HORSESHOE RIDGE SUBDIVISION 1ST AMENDMENT

LOT 1, BLOCK 1, HORSESHOE RIDGE SUBDIVISION 1ST AMENDMENT

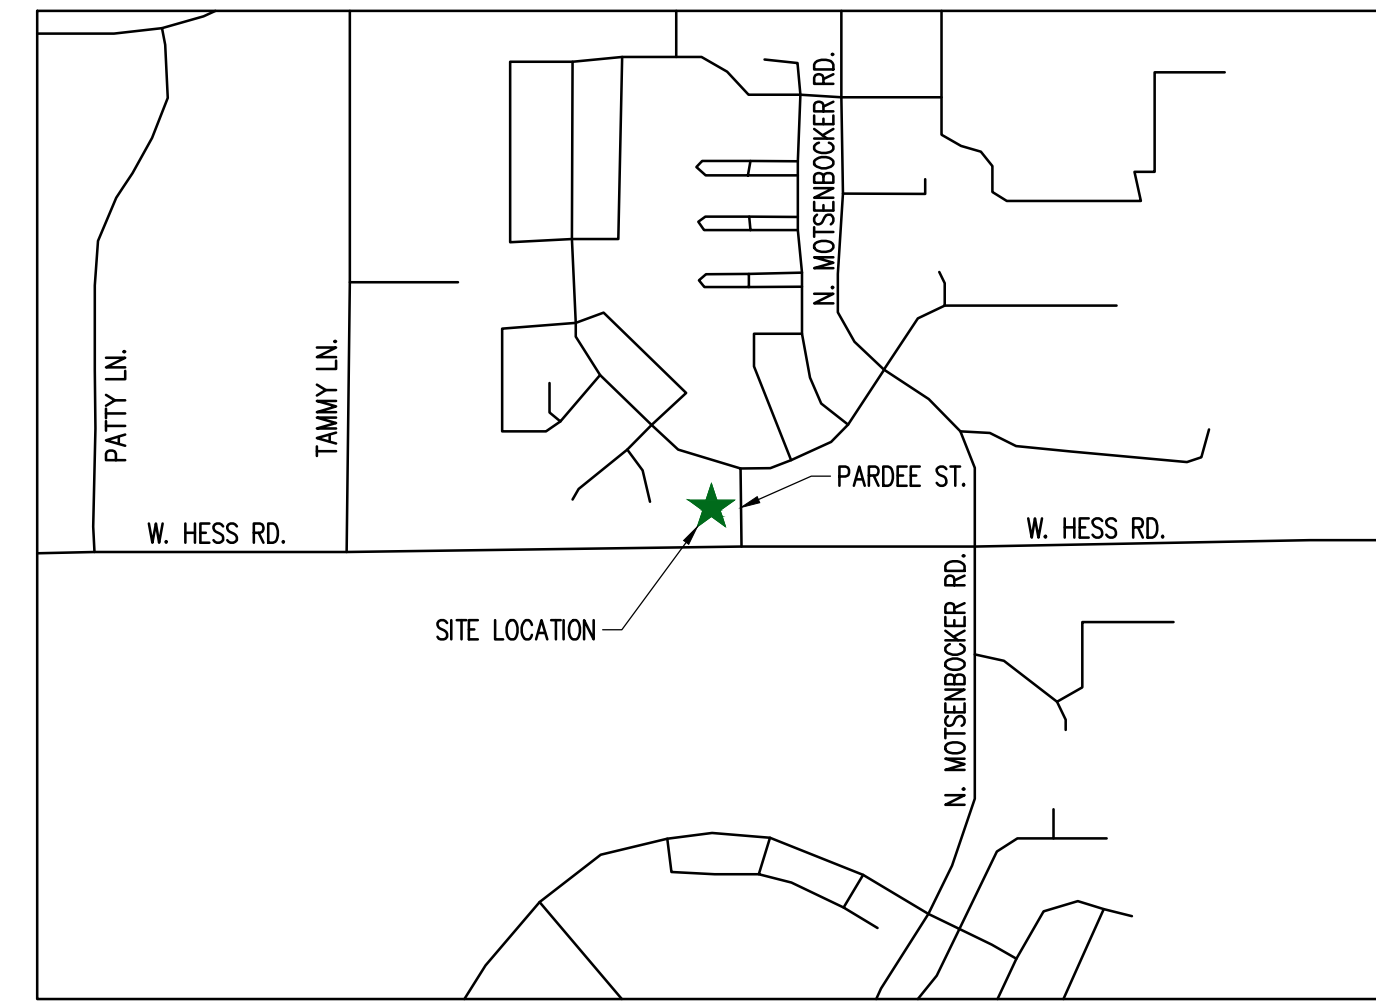
SITE PLAN REVIEW
